Road Safety Audit Existing Stage

**Western Arterial Road
(Toowong – Everton Park)
Chainage 1.40km – 2.00km**

Prepared for Department of Transport and Main roads (Metropolitan Region)

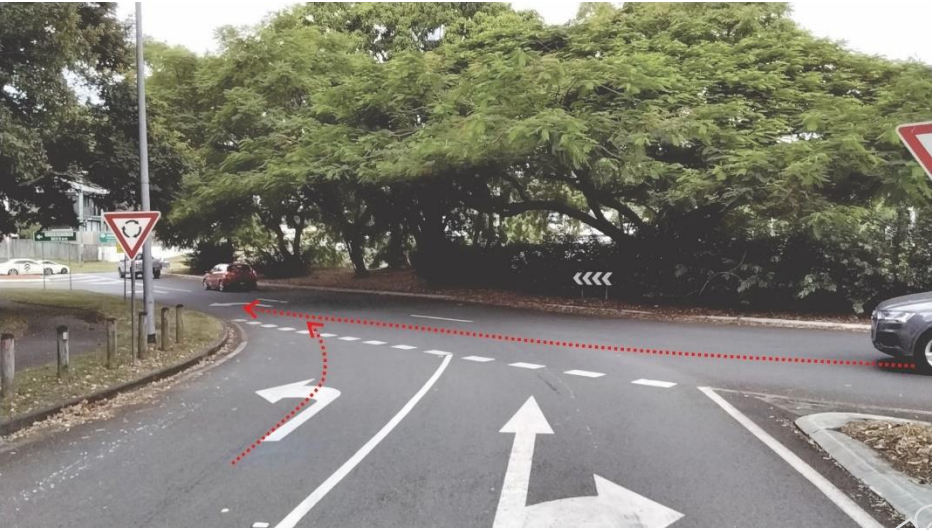
Item no.	Audit findings	Suggested action	Priority
<p>6.3.1 Cont'd.</p>	 <p>Photograph 12: Approach to southern roundabout on Boundary Road.</p>  <p>Photograph 13: Southern roundabout, view looking north from Western Arterial Road. Due to a lack of lane line markings, circulating vehicles intending to change lanes and make a left-turn exit conflicted with vehicles entering the roundabout from the left lane.</p>

Figure 7: Extract from TMR’s *Principal Cycle Network Plan (SEQ) 2016*. As indicated on the map, Western Arterial Road and Boundary Road are identified as principal cycling routes.

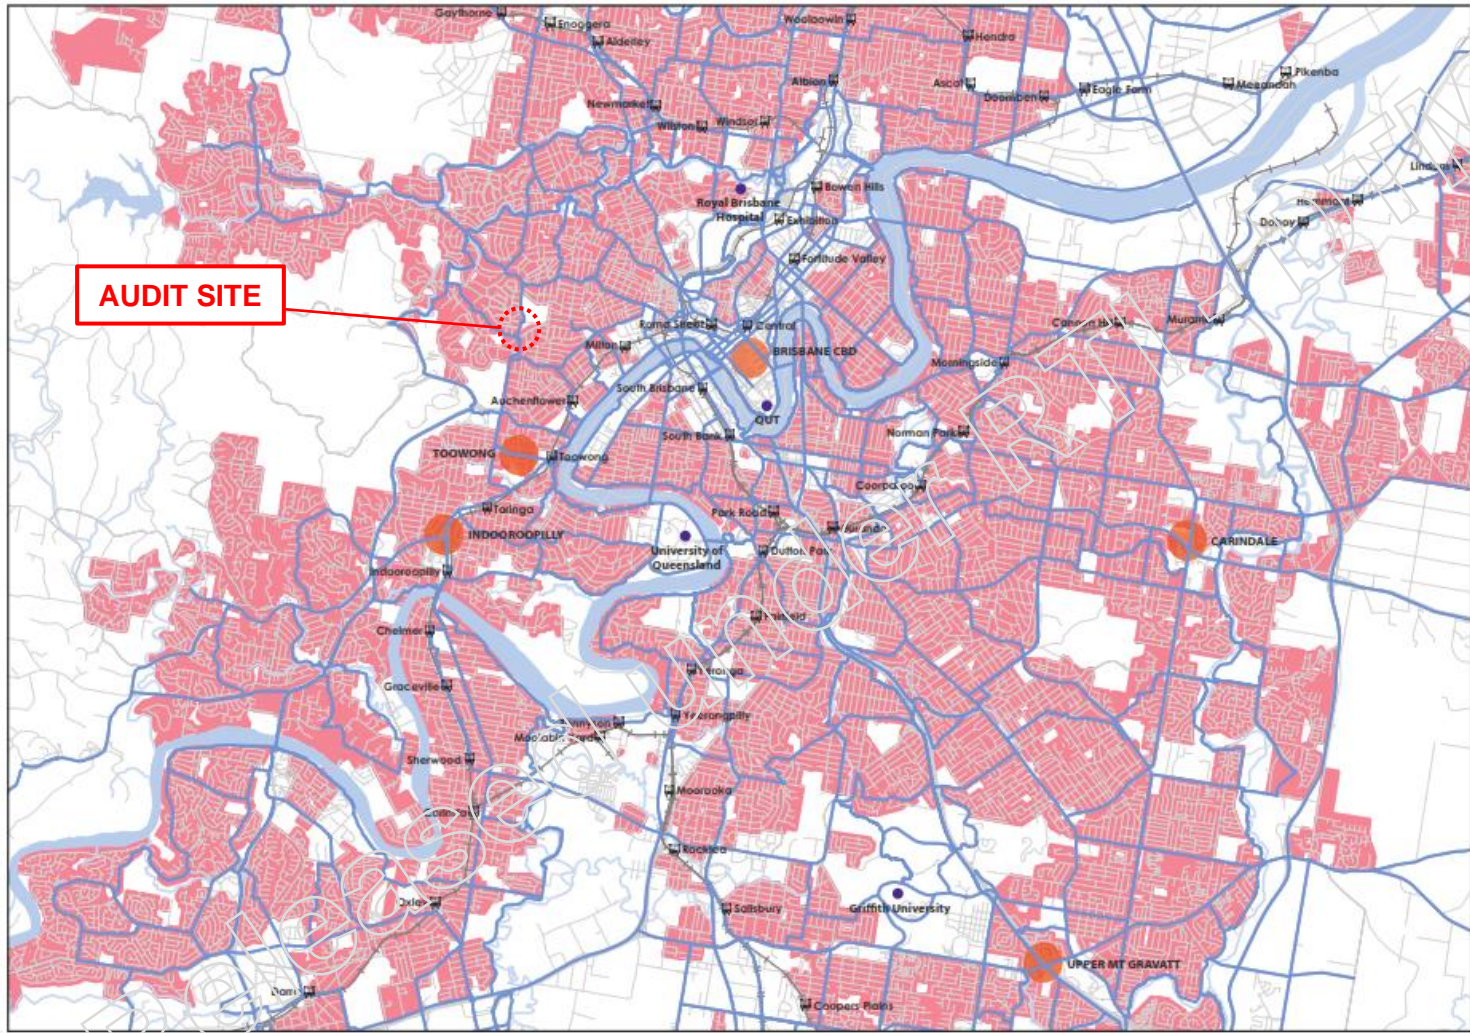
Item no.	Audit findings	Suggested action	Priority
6.8.3	<p>Dedicated bicycle lanes or formal shared bicycle/pedestrian paths were not provided throughout the audit site. TMR's <i>Principal Cycle Network Plan (2016)</i> indicate Western Arterial Road and Boundary Road (western leg off southern roundabout) are both principal cycling routes.</p> <p>During the day inspections a small number of on-road cyclists were observed navigating the southern roundabout. A number of cyclists were also observed to use off-road paths to cross Western Arterial Road at the 'zebra crossing' located on the northern leg of the southern roundabout.</p> <p>The layout of both roundabouts presented safety risks for on-road cyclists. Enhancing safety for cyclists would be highly beneficial and could be achieved using one or more toolbox treatments provided in TMR's guideline <i>Providing for people walking and riding bikes at roundabouts (2022)</i>.</p>	<p>Recommendation 6.8.3.1</p> <p>Review and verify the status of principal cycling routes in relation to the audit site. Where there is a need for enhanced cycling infrastructure within the audit site, incorporating appropriate toolbox treatments outlined in TMR guidelines as part of upcoming upgrade projects or future planning initiatives. Where funding is limited, consider a staged implementation and prioritise actions accordingly.</p>	<p>L = Unlikely S = Serious P = High (FSI)</p>
